## APPLICATION FOR GATEWAY EARTH STATION

This application, filed by a sister company, SpaceX Services, Inc. (“SpaceX Services”), seeks authority to operate a Ka-band gateway earth station that SpaceX will use to deliver broadband data between the satellites of its NGSO system and terrestrial Internet exchange points. Specifically, SpaceX Services seeks authority for eight technically identical 1.5-meter antennas in Coalville, Utah (the “Coalville Gateway”). Consistent with SpaceX’s space station authorization, these earth stations will transmit in the 27.5-29.1 GHz and 29.5-30.0 GHz bands and receive in the 17.8-18.6 GHz and 18.8-19.3 GHz bands.

## TECHNICAL APPENDIX

**Figure 1. PFD Contours for Coalville Gateway**

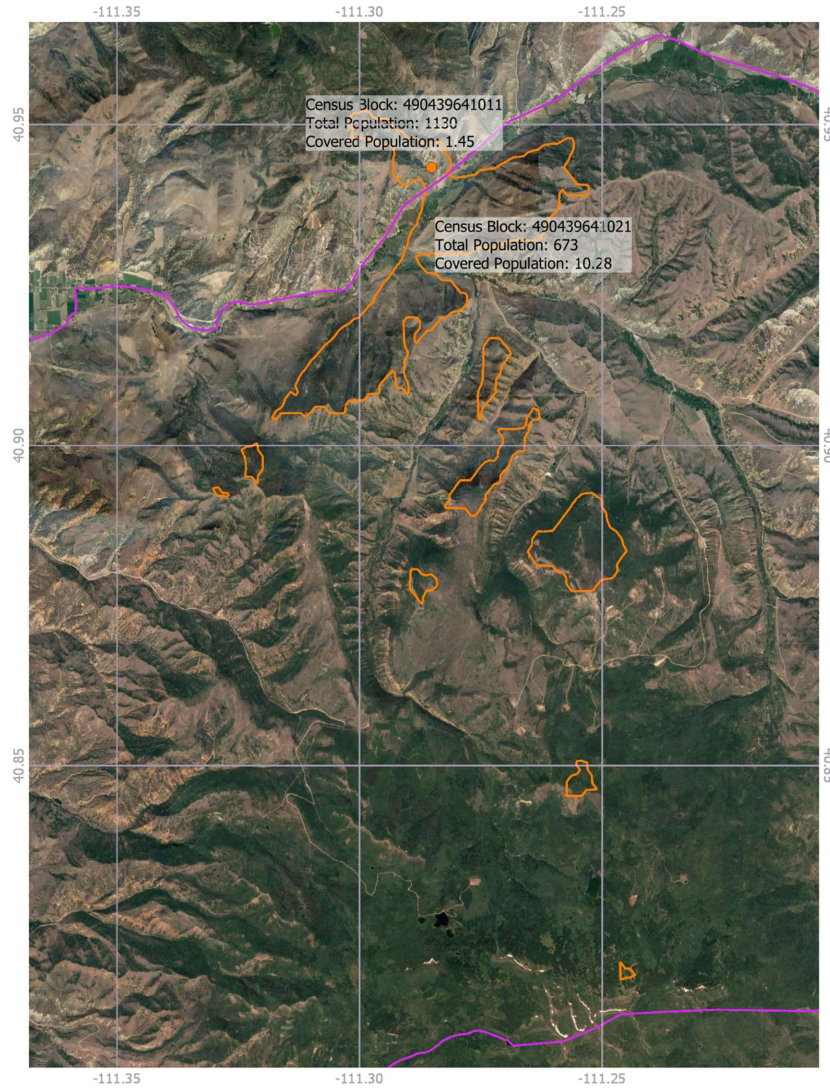
**Commented [WW2]:** Why are there contours in two different colors? The purple does not look like it is emanating from the proposed gateway site.

**Commented [WW4]:** Where does Figure 1 show census blocks?

**Commented [AG3R2]:** Purple is the census block boundaries. Initially we were zooming out far enough to show the hole census block boundary however later per given feedback we have zoomed in to the extends of the PFD contour.

**Commented [AG5R4]:** Purple is the census block boundaries. Initially we were zooming out far enough to show the whole census block boundary however later per given feedback we have zoomed in to the extends of the PFD contour.
